PRELODGE MENT PANEL ADVICE EIS CONSULTATION AND ADVICE

PROPERTY:	2-4 Giffnock Avenue, Macquarie Park	
MEETING DATE:	5 June 2025	TIME: 2pm to 3pm
PRELODGE MENT No:	PRL2025/0014	
DEVELOPMENT:	Mixed-use development comprising two tower elements above podiums, with retail premises, a childcare centre and residential uses within the building envelopes and recreation and infrastructure uses on the remainder of the site.	
ATTENDANCE:		
Council:		
Nicholas Najar	Acting Senior Co-Ordinator Development Advisory Service	
Michael Cuthbert	Infrastructure Strategy & Planning Coordinator	
Mark Taylor	Senior Coordinator Park Planning	
Daniel Pearce	Senior Coordinator Engineering & Landscaping Services	
Joey Huang	Acting Senior Coordinator Transport Development Services	
Robert Platt	Development Contributions Coordinator	
Leila Faghihi	Senior Engineer Stormwater & Floodplain Management	
Justin Byrne	Senior Civil Engineer Activation & Compliance	
Jeremy Giacomini	City Architect

Figure 4: Mark up of Zoning Extract (Base Source: Ryde Maps)

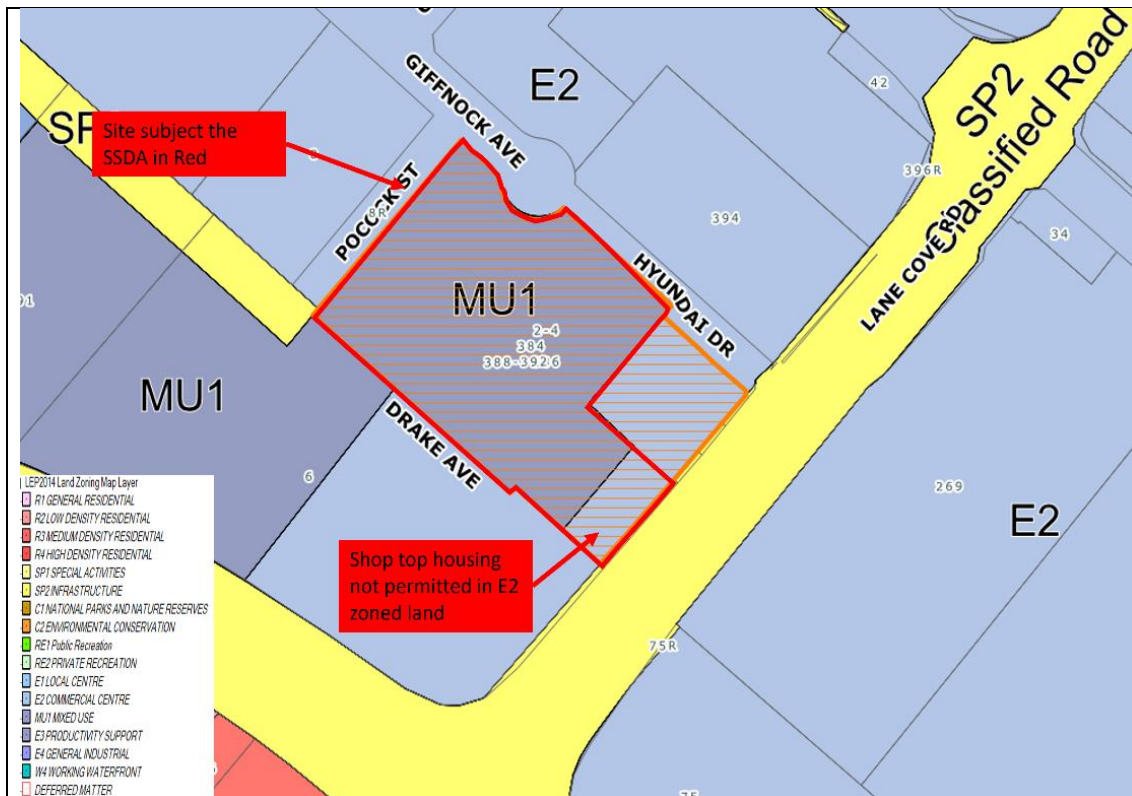
Council notes that part of the site that is zoned E2 does not permit Shop Top Housing with development consent, therefore it is recommended that no part of the shop top housing is to protrude into the zone boundary of E2 Land. To demonstrate this, it is recommended that the architectural plans overlay the zone boundaries on the plans.

As noted in the meeting with the Applicant, the FSR plans have included the land zoned E2 in its calculation (refer Figure 4). The E2 zone does not permit the land use "Residential Accommodation" which shop top housing is a subcategory of.

As part of the site is zoned E2 which prohibits Shop top housing (by virtue of prohibiting "residential accommodation"), the area associated with the E2 zoning cannot be included in the site area for the purposes of FSR calculation.

- A clear GFA schedule is provided that breaks down the site area for which GFA is calculated from.
- The plans clearly nominate the area inclusive of the site that is zoned E2. The applicant may need to undertake detailed zone boundary investigations to accurately determine this.
- A detailed Clause 4.6 request that clearly demonstrates there are sufficient environmental planning grounds to justify the exceedance.

Figure 7: Extract showing pedestrian bridge link (Source: Studio.SC)

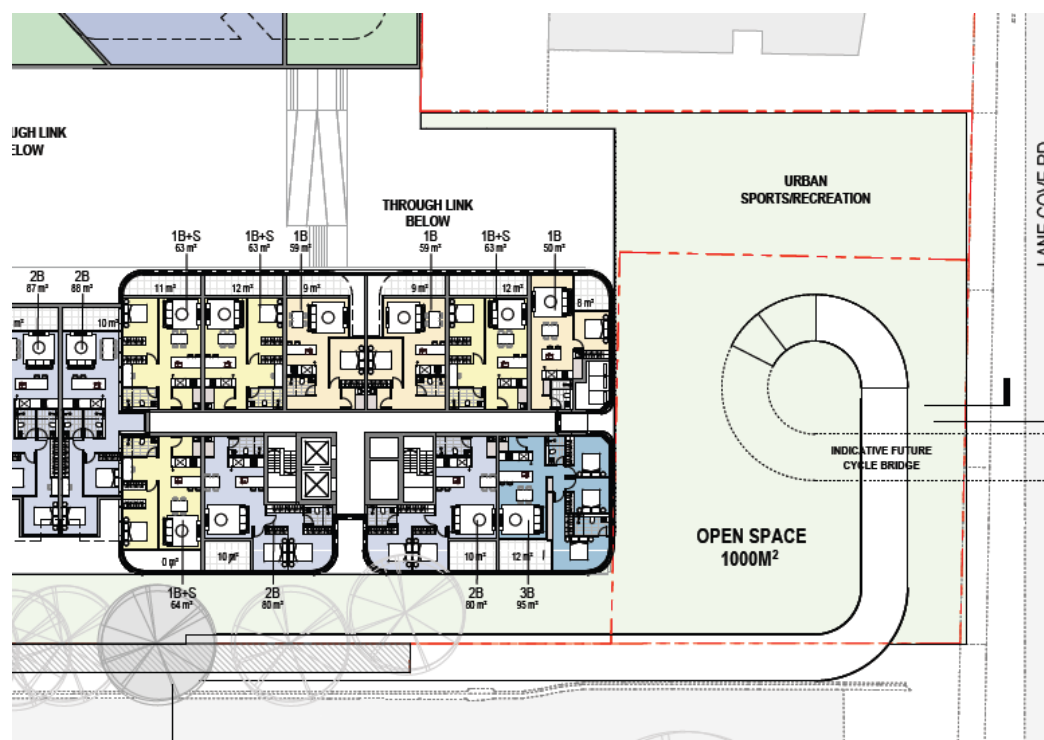
The proposed layout of the land dedication to facilitate the bridge is shown Figure 7. The proposed arrangement shows a loop road within an almost square area of land. The proposed access is only from Drake Avenue, with access directly from the Metro not being preferable. It is also noted that part of the proposed bridge approach is on the neighbouring property – Key Site 5 which would not be delivered until after the operation of the subject site.

The above arrangement is not considered to provide for the optimal access arrangements, both in terms of the distance in travel required to and from the Metro Station to access it and also in terms of gradient. To be of maximum utility to the public the bridge should provide convenient access to and from the Metro Station and other important high-volume areas and be easy to use for cyclists and pedestrians by being of an adequate gradient.

There is an opportunity to amend the dedication area to provide for better access to Macquarie Park Metro Station while also providing shallower grades which will be more preferable to pedestrians and cyclists.

Figure 10: Sketch showing potential amended design of pedestrian bridge (Base Source: Studio.SC)

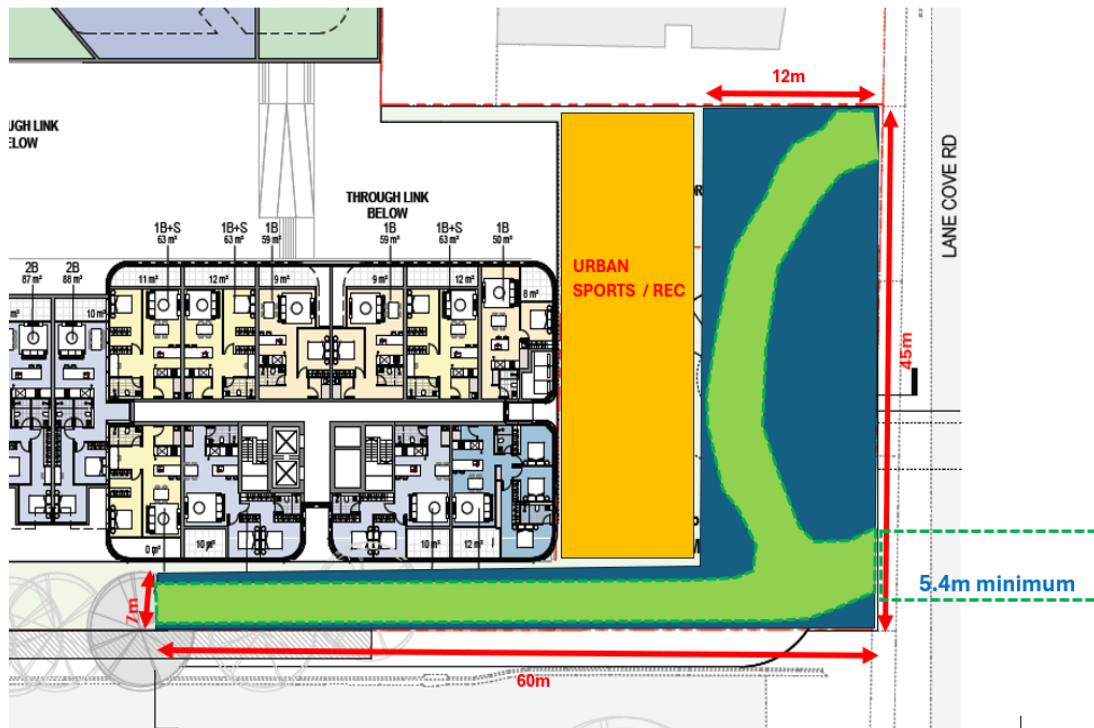
The amended arrangement below (Figure 10) shows an L-shaped dedication areas, facilitating dual access ramps from both Lane Cove Road and Drake Avenue. This amended arrangement would enable direct access between the Metro Station and the overpass which would likely greatly improve the community utility of the bridge.

It's recommended to explore different dedication scenarios to ensure that the future design of the pedestrian bridge adequately services the community. This arrangement should be discussed with TfNSW as the authority the land is to be dedicated too.
